STATE OF UTAH
DEPARTMENT OF NATURAL RESOURCES
DIVISION OF OIL, GAS AND MINING

APPLICATION FOR PERMIT TO DRILL				5. MINERAL LEASE NO: ML-21330	6. SURFACE: State
1A. TYPE OF WORK: DRILL <input checked="" type="checkbox"/> REENTER <input type="checkbox"/> DEEPEN <input type="checkbox"/>				7. IF INDIAN, ALLOTTEE OR TRIBE NAME:

2. NAME OF OPERATOR: KERR MCGEE OIL & GAS ONSHORE L.P.				9. WELL NAME and NUMBER: NBU 1021-29C	
3. ADDRESS OF OPERATOR: 1368 S 1200 E CITY VERNAL STATE UT ZIP 84078			PHONE NUMBER: (435) 781-7024	10. FIELD AND POOL, OR WILDCAT: NATURAL BUTTES

API NUMBER ASSIGNED: 43-047-39018

**NBU #1022-19C
SECTION 19, T10S, R22E, S.L.B.&M.
896' FNL 1891' FWL**

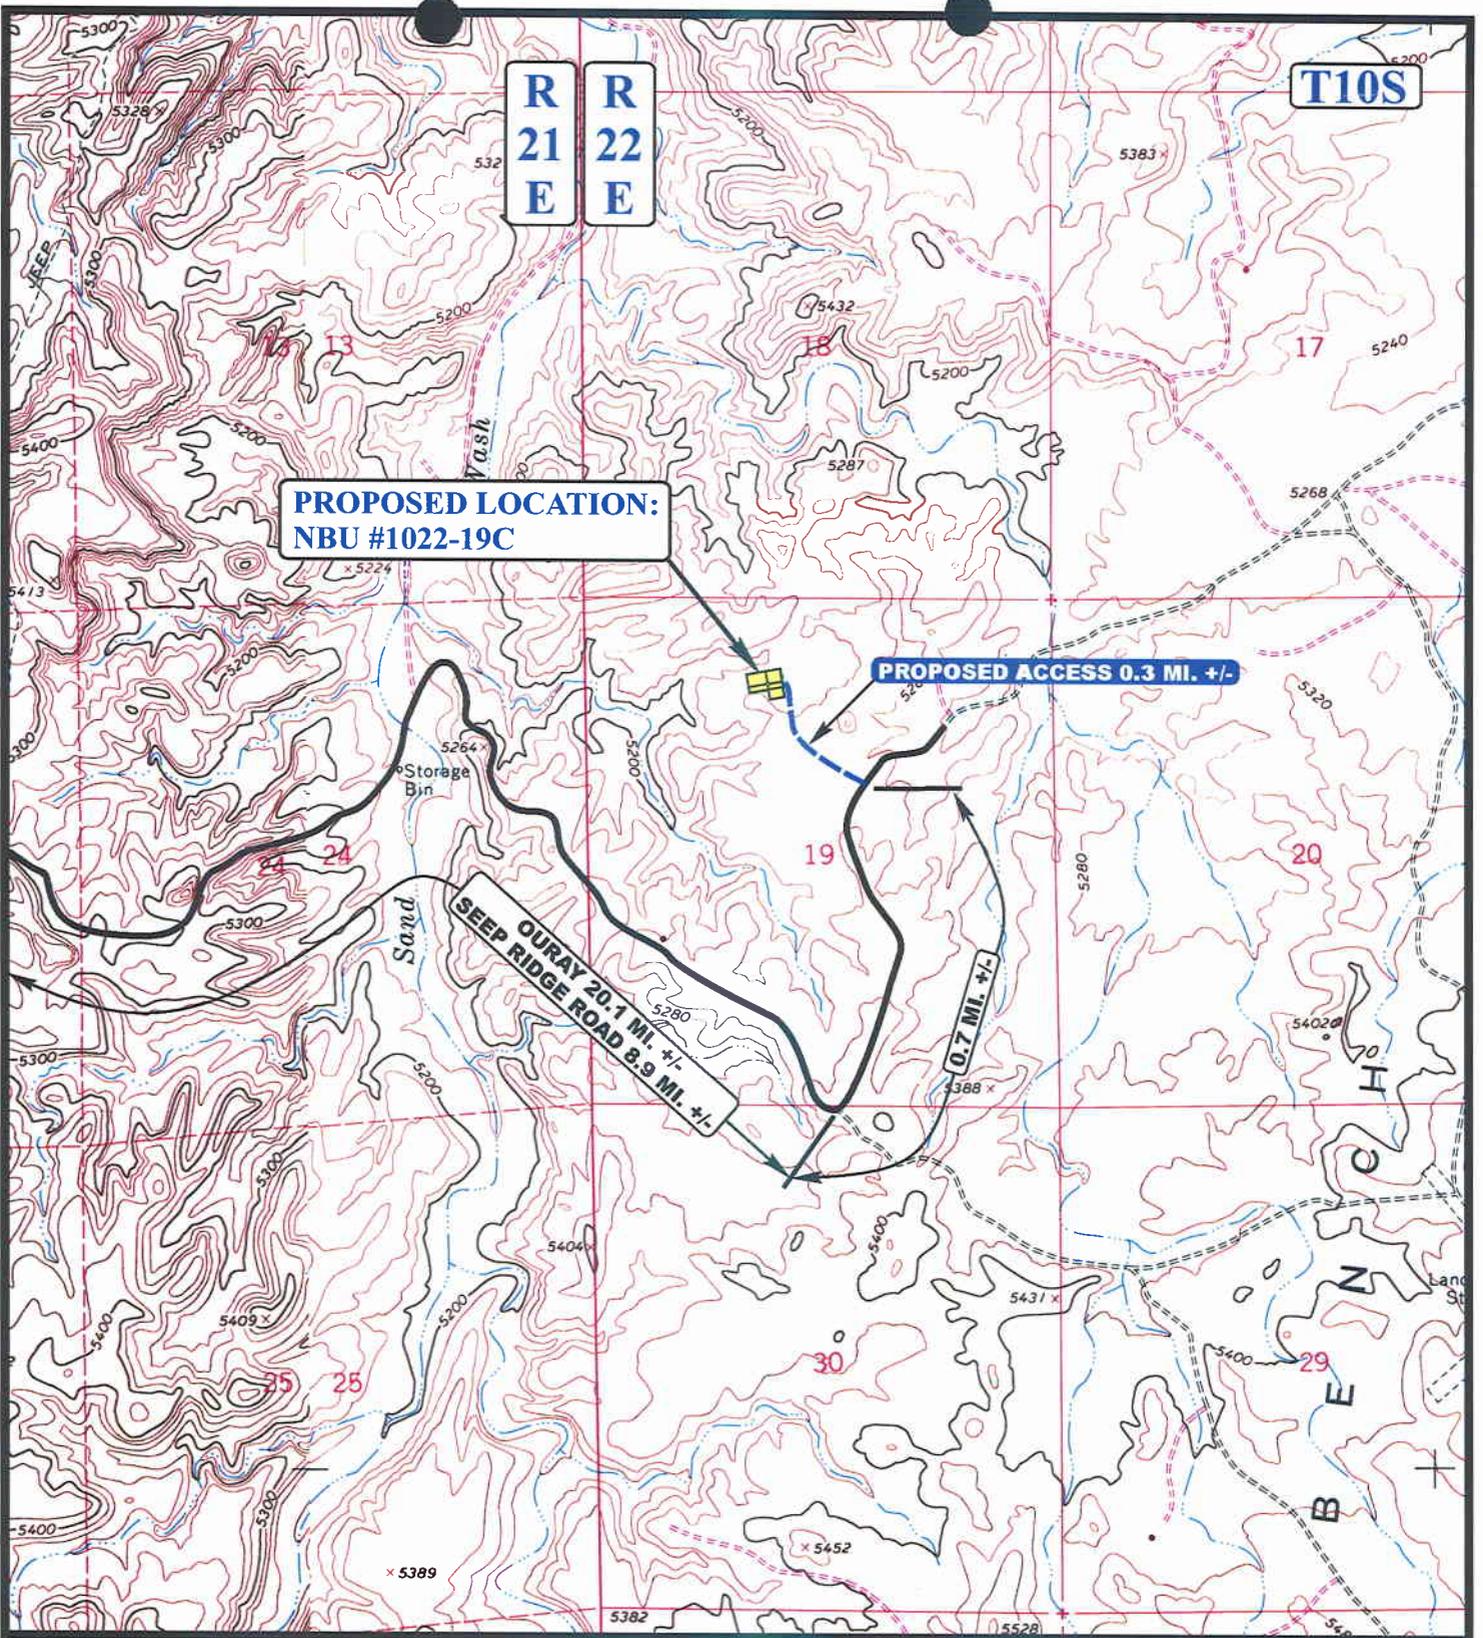
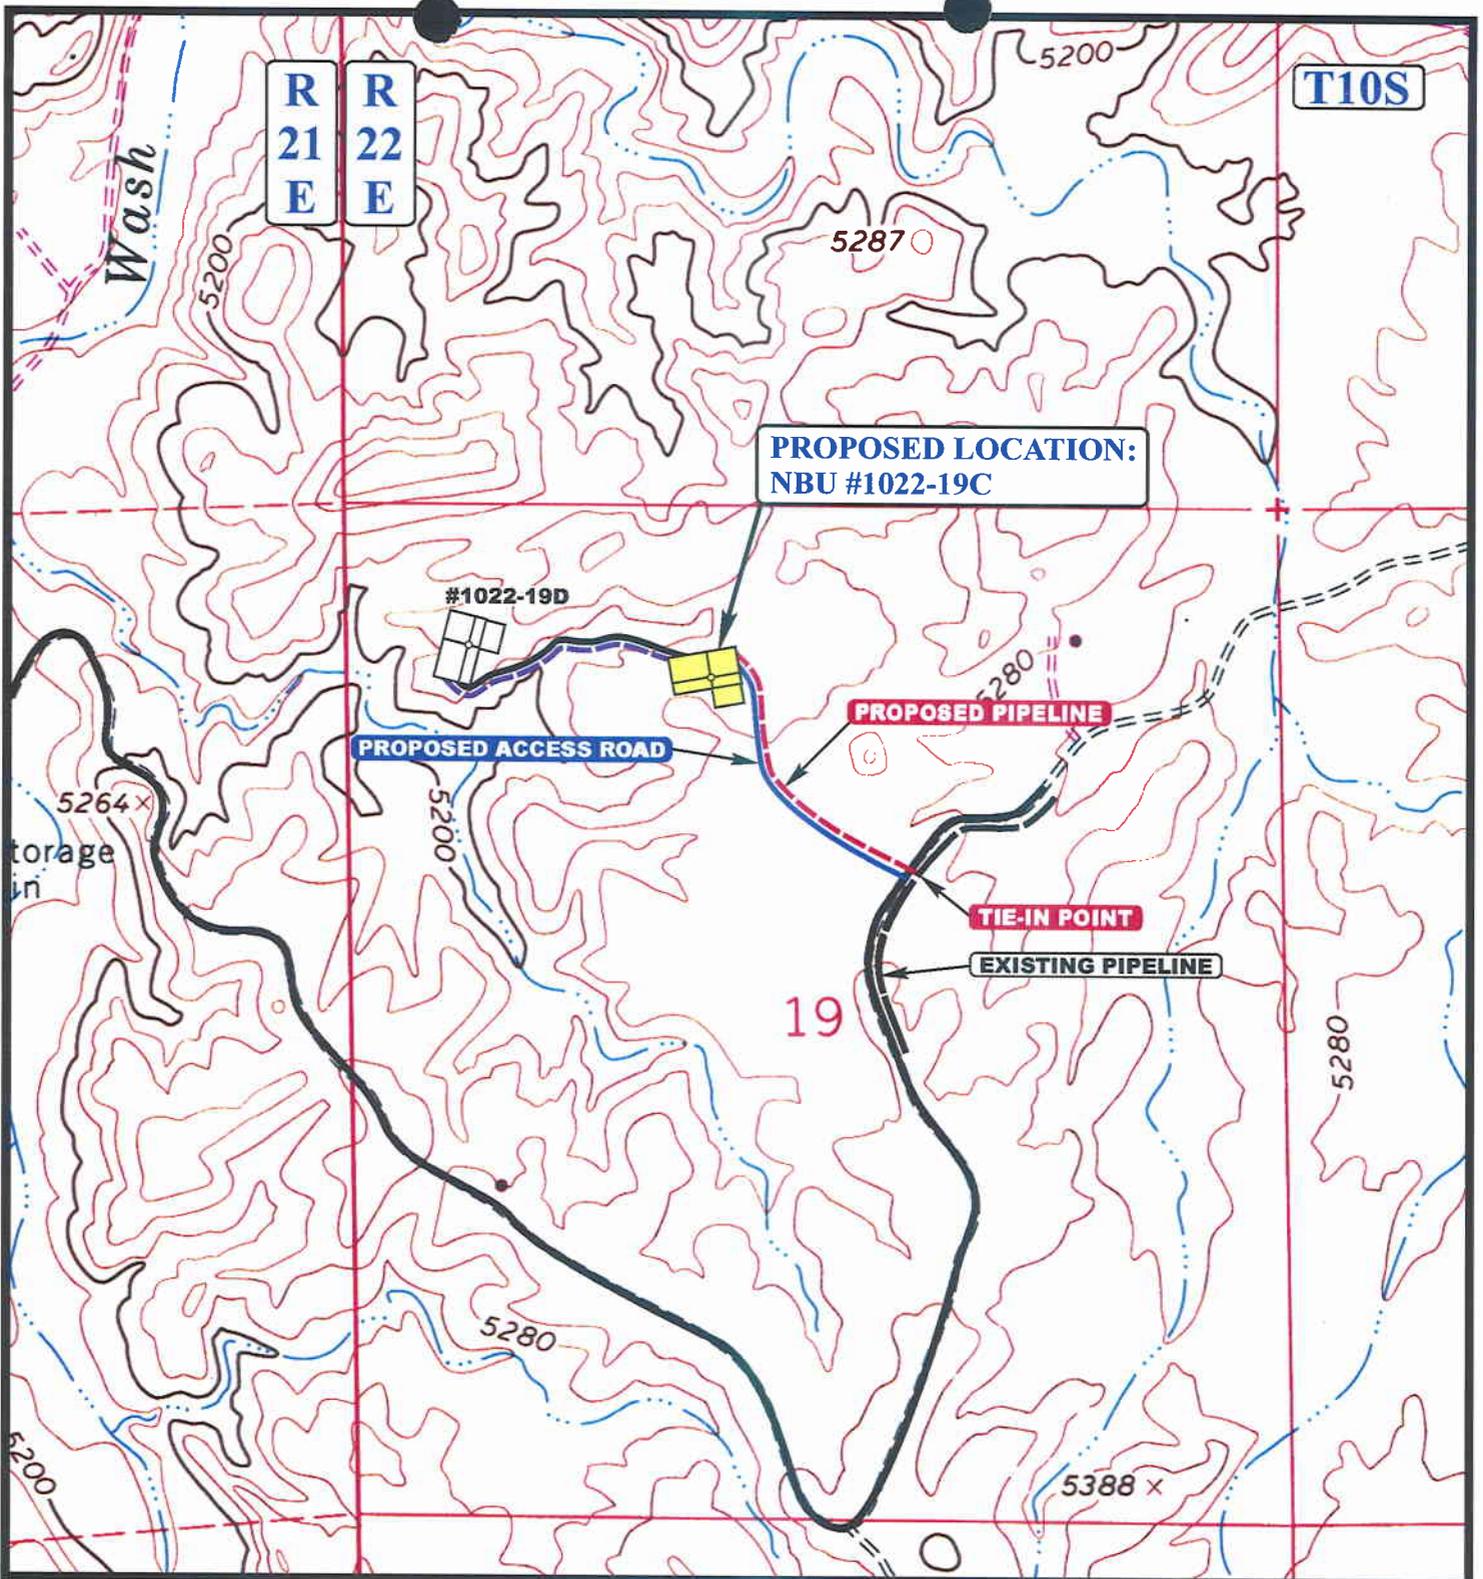
AN ON-SITE INSPECTION WAS CONDUCTED ON 02/13/2007 WITH UDOGM AND SITLA REPRESENTATIVES. IT WAS DECIDED AT THE ON-SITE INSPECTION TO CHANGE THE PROPOSED ACCESS ROAD FROM 0.2 +/- MILES TO 0.3 +/- MILES. THE PIPELINE WAS CHANGED FROM 2000' +/- OF 4" STEEL TO APPROXIMATELY 1594' +/- OF 4" STEEL PIPELINE.

PLEASE REFER TO THE ATTACHED REVISED TOPO MAPS FOR ACCESS ROAD AND PIPELINE PLACEMENT.

**PROPOSED LOCATION:
NBU #1022-19C**

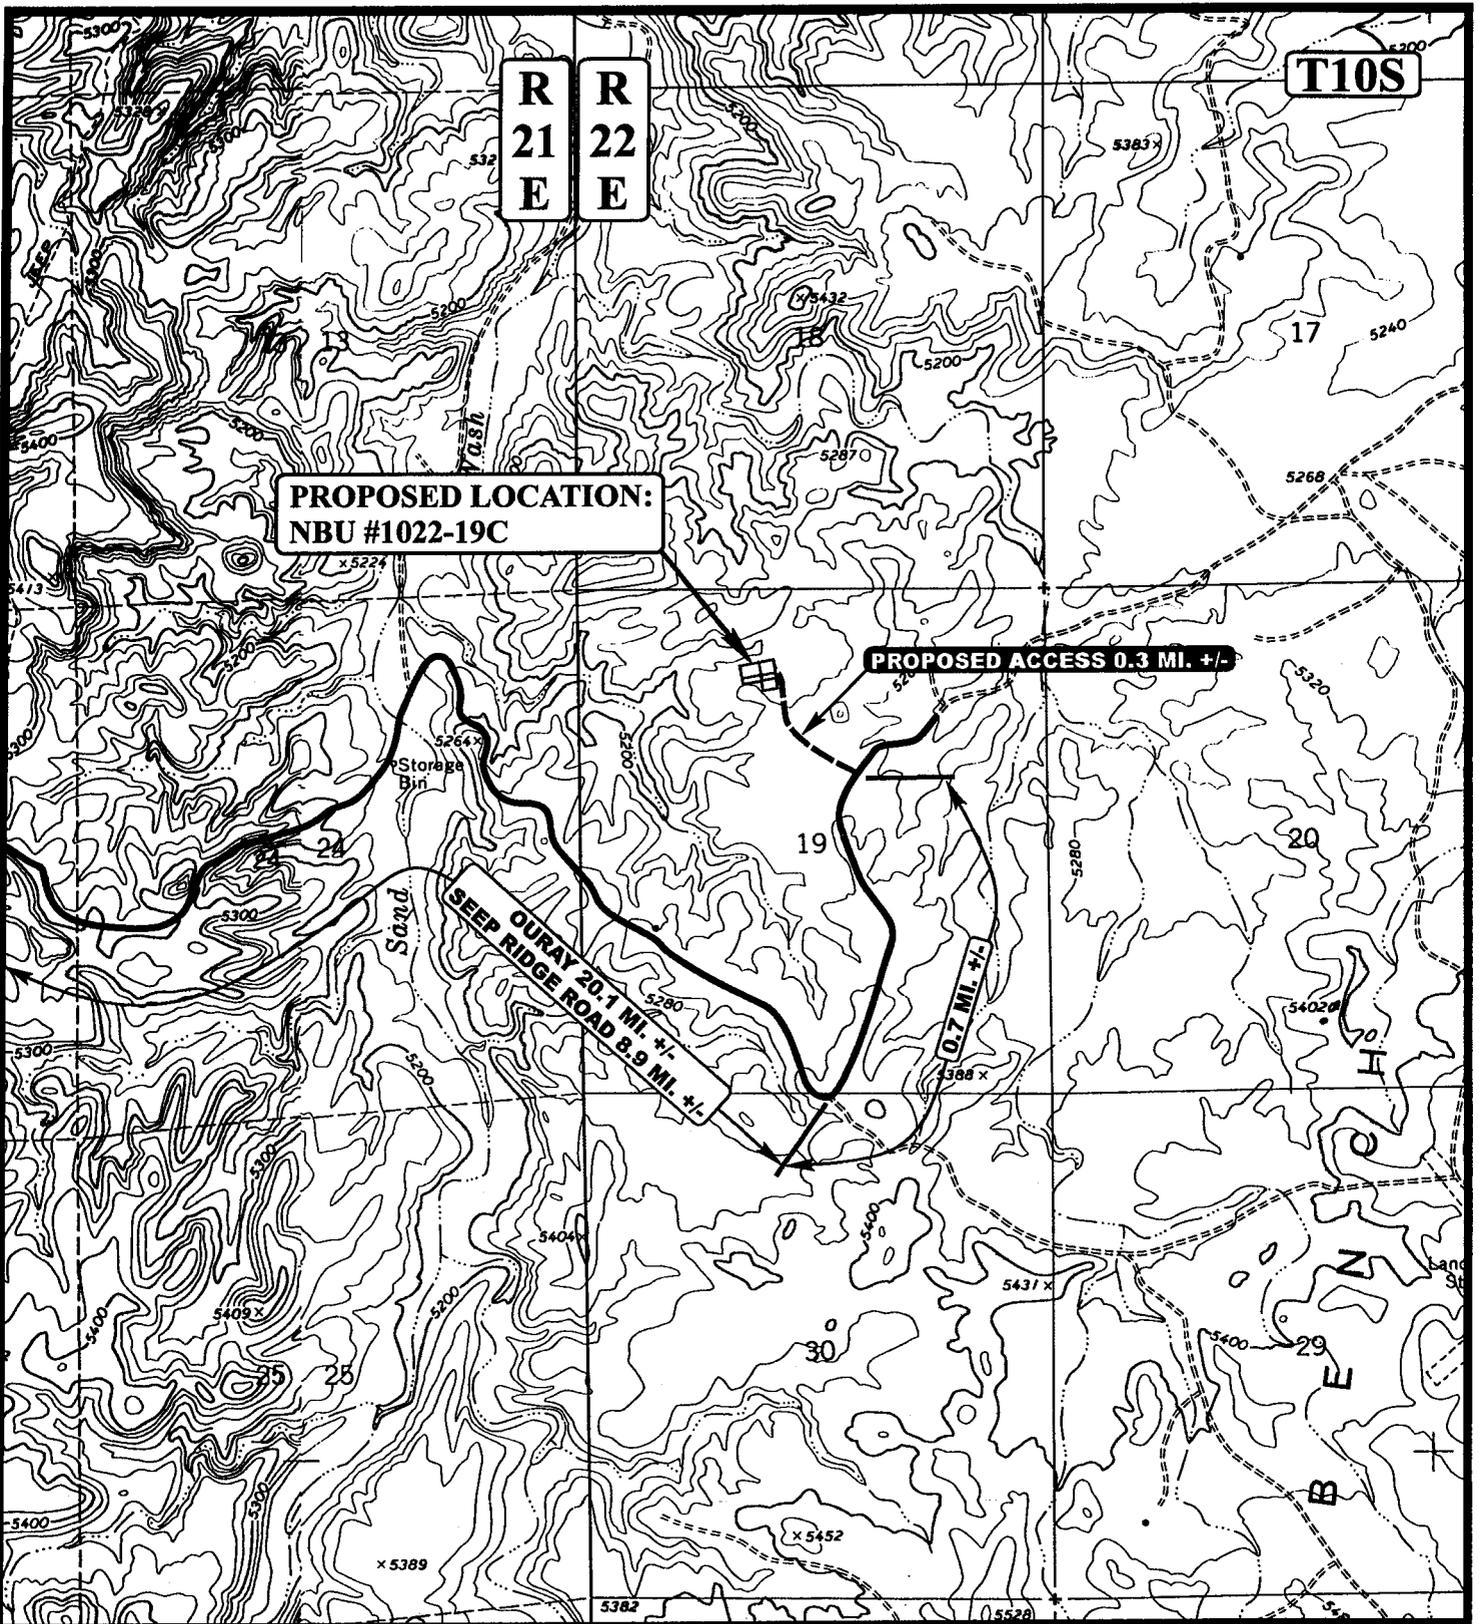
AN ON-SITE INSPECTION WAS CONDUCTED ON 02/13/2007 WITH UDOGM AND SITLA REPRESENTATIVES. IT WAS DECIDED AT THE ON-SITE INSPECTION TO CHANGE THE PROPOSED ACCESS ROAD FROM 0.2 +/- MILES TO 0.3 +/- MILES. THE PIPELINE WAS CHANGED FROM 2000' +/- OF 4" STEEL TO APPROXIMATELY 1594' +/- OF 4" STEEL PIPELINE.

PLEASE REFER TO THE ATTACHED REVISED TOPO MAPS FOR ACCESS ROAD AND PIPELINE PLACEMENT.
